SUNDRY NOTICES AND REPORTS ON WELLS

1. Type of Well ☐ ☐ Gas Well ☐ ☐ Other		Hondo 4 Fed 2-5 8. Well Name and No.		
2. Name of Operator Matador Production Company			Hondo 4 Federal #2	
3a. Address 3b. Phone No. (include area code)		9. API Well No. 30-015-25296		
PO BOX 1936 ~ ROSWELL NM 88202-1936 575.623.6601		10. Field and Pool, or Exploratory Area

Hondo 4 Federal 2 30-015-25296 Matador Production Company February 12, 2016 Conditions of Approval

Permanent Abandonment of Production Zone Conditions of Approval

Proposed Wellbore

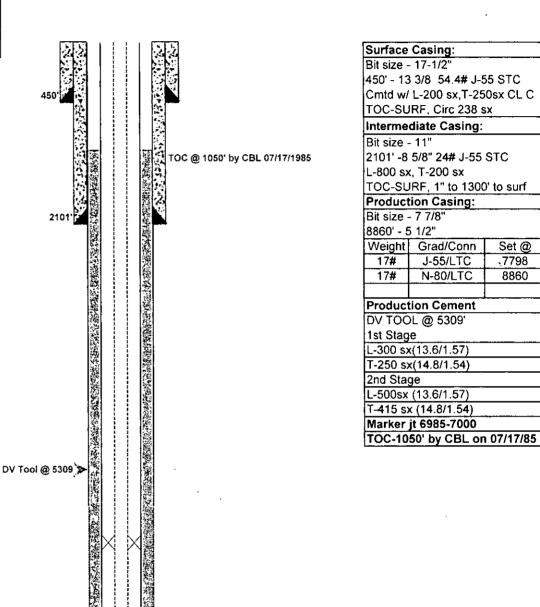
- 1. Operator shall place CIBP at 8,200' (50'-100' above top most perf) and place 35' of Class H cement on top. WOC and tag.
- 2. Must conduct a casing integrity test before perforating and fracturing. Submit results to BLM. The CIT is to be performed on the production casing to max treating pressure. Notify BLM if test fails
